Taillight Dash Error Message – Resistors

Bulletin Type:	Recall	Publication Date:	June 2026
Bulletin #(s):	26V-361 USA 2026-269 CANADA	Make(s):	Jayco & Entegra Coach
Job Code(s):	9903657	Model(s):	Condor, Granite Ridge, Melbourne, & Qwest SE
Flat Rate(s):	9903657 – .75 HR - Installation of jumper harness	Model Year(s):	2026

Incident:	Dash is displaying taillight warning messages for right and left taillights when lights are functioning correctly.
Affected Units:	2026 Jayco Granite Ridge & Melbourne & 2026 Entegra Coach Condor & Qwest SE
Parts Kit: 26V-361	Parts Kit #: 26V-361
	1 Qty - HARNESS, RES 100 OHM HARN TLT SPNTR W/WIRE LEADS
Misc. Tools & Supplies:	Wire Strippers Ratchet with ½" socket and ½" Wrench
Parts Return Information:	N/A

Fig. 1

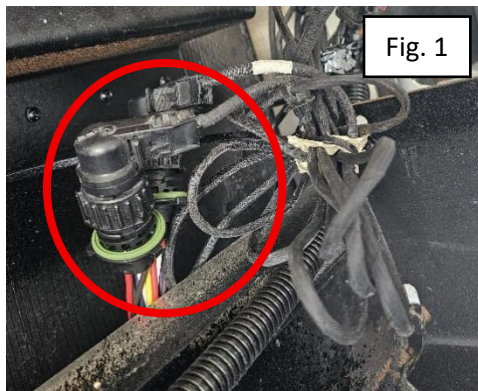
1. Disconnect the two 7-Way cavity plugs under the chassis. It is near the rear drive side leveling leg. (Figure 1)

Fig. 2

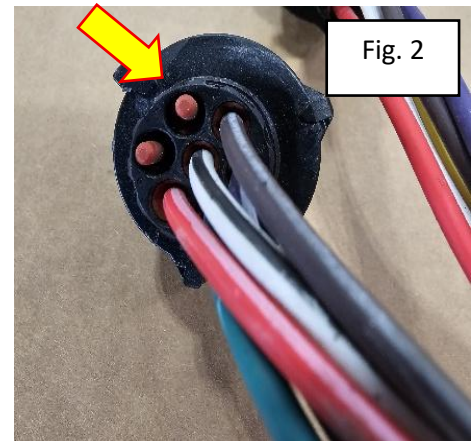
2. On one of the plugs Locate Pin 7. Using Wire Strippers, remove the plug in pin 7. (Figure 2)
3. Insert one of the pins from the resistor harness into pin 7. (Figure 3)
4. Locate pin 7 on the second connector, remove the plug from pin 7. (Figure 2)
5. Insert the second pin from the resistor harness into pin 7 of the second connector. (Figure 3)
6. Re-connect the two 7-Way cavity plugs underneath the coach. (Figure 1)
7. Remove the bolt for the chassis ground near the driver side rear leveling jack using a ½" wrench and ratchet with ½" socket. Attach the chassis frame ground from the resistor harness to the bolt and re-install.
 - a. **Note: When adding the ground to the chassis frame ground stud, ensure there is a star washer on the stud and if not add one.** (Figure 4)
8. Mount the resistors to the frame rail. (Figure 5)
9. Secure any loose wiring using cable/zip ties or p-clamps
